Ducted Systems Technical Services: Service Tips Letter

Letter: ST-010-22

Subject: **Choice IOM Missing Airflow Chart**

Product/s: **Choice Equipment 15 to 27.5 Tons (AV/CV/CD 15 thru 27.5 Tons) Serial Number Range N2D2 to Current.**

Figure 79:

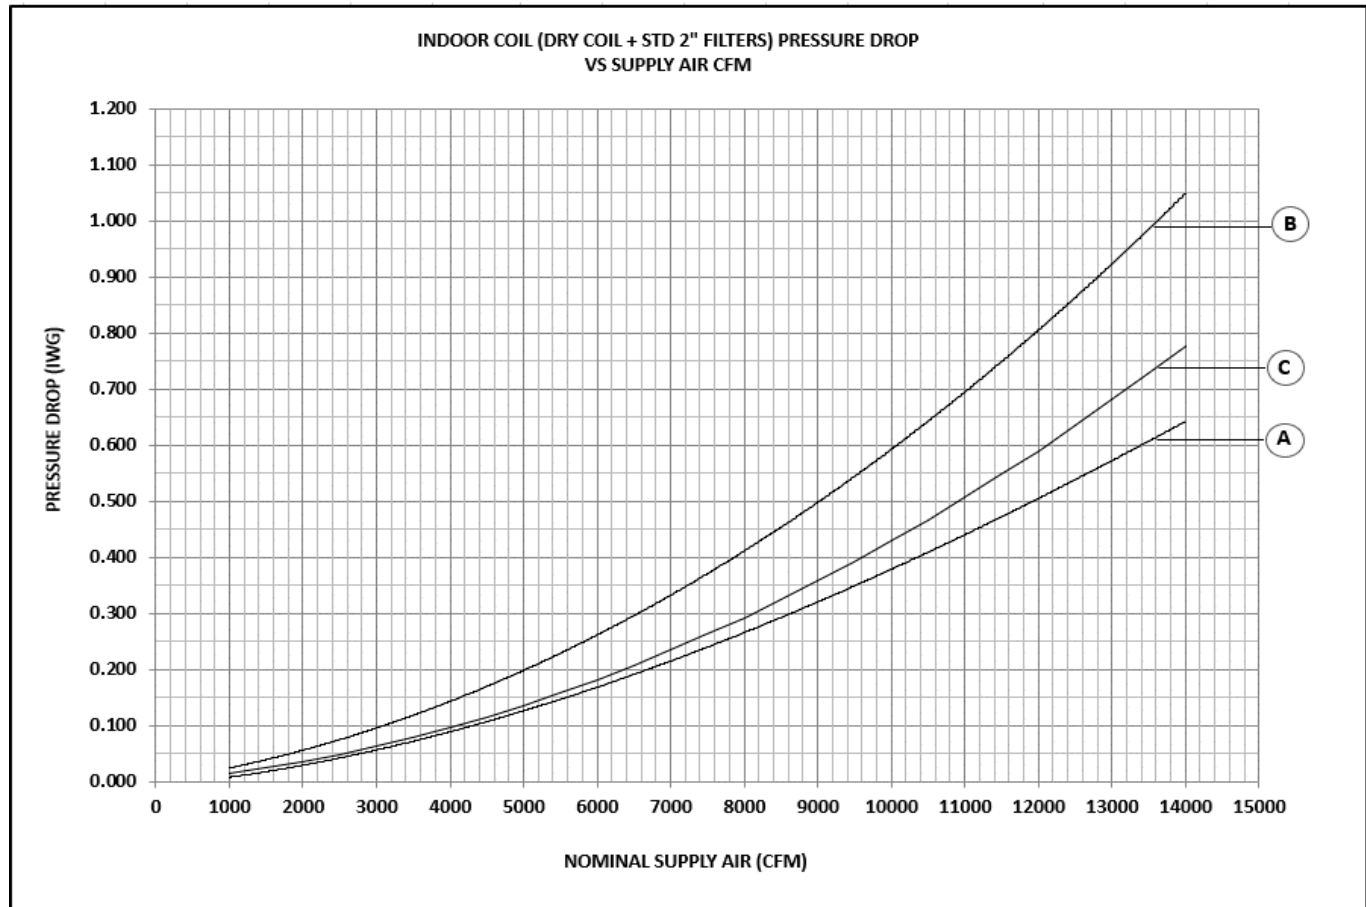
Johnson Controls Commercial Technical Services has been informed that the current published installation Manual for Choice products is missing "Figure 79" in the airflow performance section. We have placed a notification to our literature team over the course of the last few months. They have received and are working to correct and republish the manuals in order to include this chart for the equipment. At this time, we wish to provide a copy of the missing "Figure 79" to allow the information to be presented while this correction takes place.
